Project	IEEE 802.16 Broadband Wireless Access Working Group < http://ieee802.org/16 >	
Title	FAST_FEEDBACK Channel Codeword Extension	
Date Submitted	2004-08-17	
Source(s)	Myung-Kwang Byun, Seungjoo Maeng, Jaeho Jeon, Soonyoung Yoon, Panyuh Joo	mk.byun@samsung.com
	Samsung Electronics Co., Ltd. Dong Suwon P.O.Box 105 416, Maetan-3dong, Yeongtong-gu, Suwon-city, Gyeonggi-do, Korea 442-600	
Re:	IEEE P802.16e/D4-2004	
Abstract	FAST_FEEDBACK Channel Codeword Extension	
Purpose	Adopting of proposed method into P802.16e	
Notice	This document has been prepared to assist IEEE 802.16. It is offered as a basis for discussion and is not binding on the contributing individual(s) or organization(s). The material in this document is subject to change in form and content after further study. The contributor(s) reserve(s) the right to add, amend or withdraw material contained herein.	
Release	The contributor grants a free, irrevocable license to the IEEE to incorporate material contained in this contribution, and any modifications thereof, in the creation of an IEEE Standards publication; to copyright in the IEEE's name any IEEE Standards publication even though it may include portions of this con

Figure 229a 231a — Subcarrier Mapping of FAST_FEEDBACK Modulation Symbols for PUSC

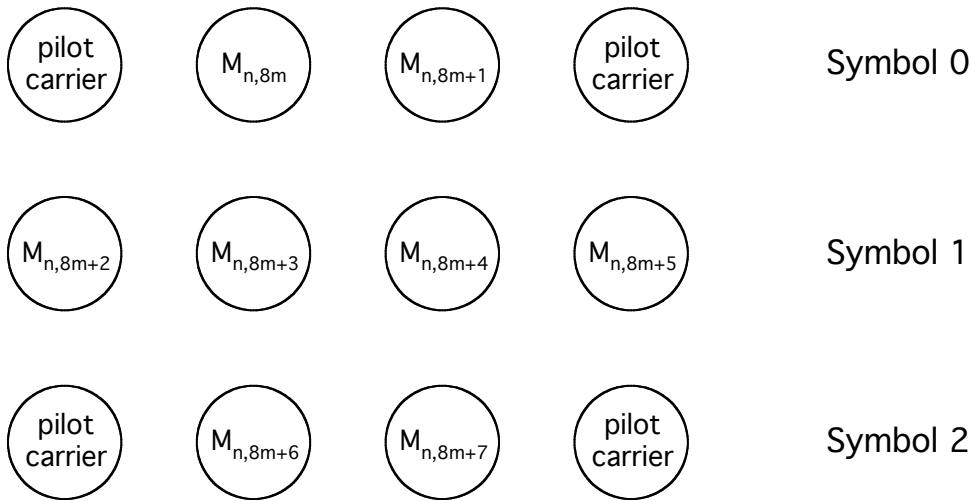
$M_{n,8m+k}$ is mapped to FAST_FEEDBACK channel tile as shown in Figure [229a](#) [231a](#) for PUSC uplink subchannel and in Figure [229b](#) [231b](#) for optional PUSC uplink subchannel. A FAST_FEEDBACK channel is mapped to one subchannel composed of 6 tiles.

Figure 229e 231c —Mapping of MIMO coefficients for **enhanced** fast MIMO feedback payload bits

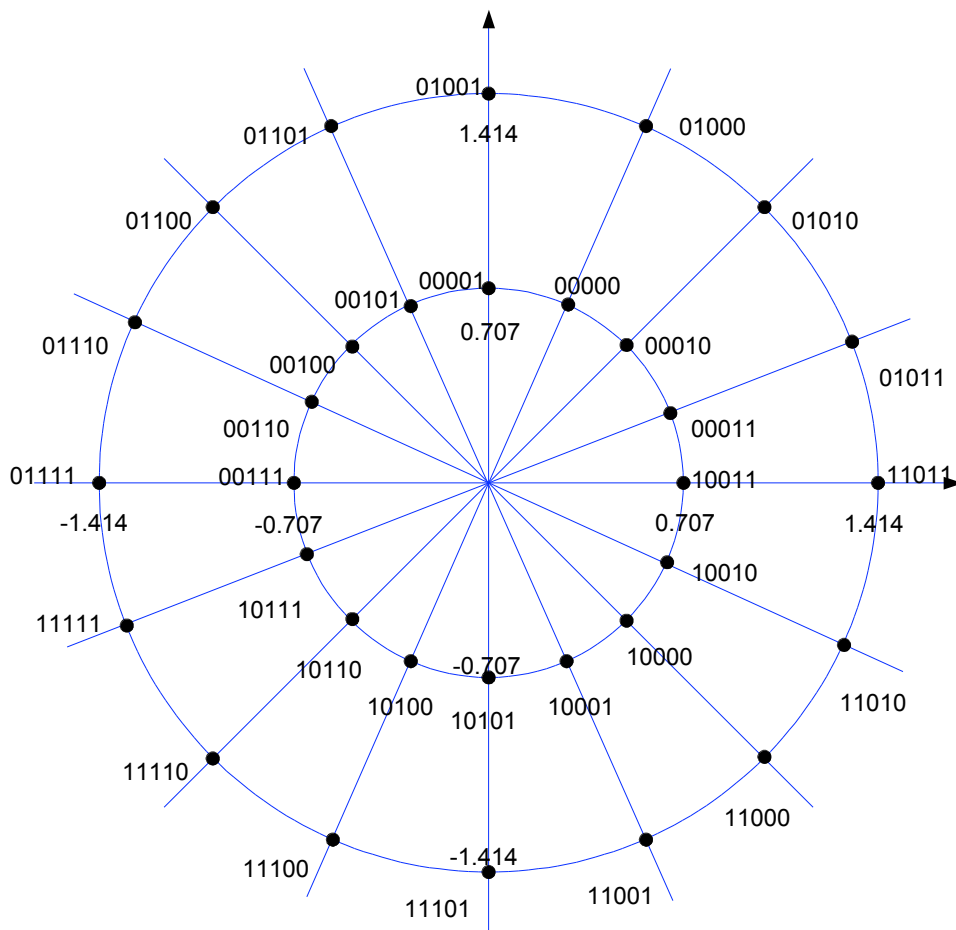
When the FAST_FEEDBACK subheader Feedback Type field is ‘01’ or ‘10’ the SS shall report the MIMO coefficient the BS should use for best DL reception (see 8.4.8.1.6). The mapping for the complex weights is shown in Figure 229e 231c.
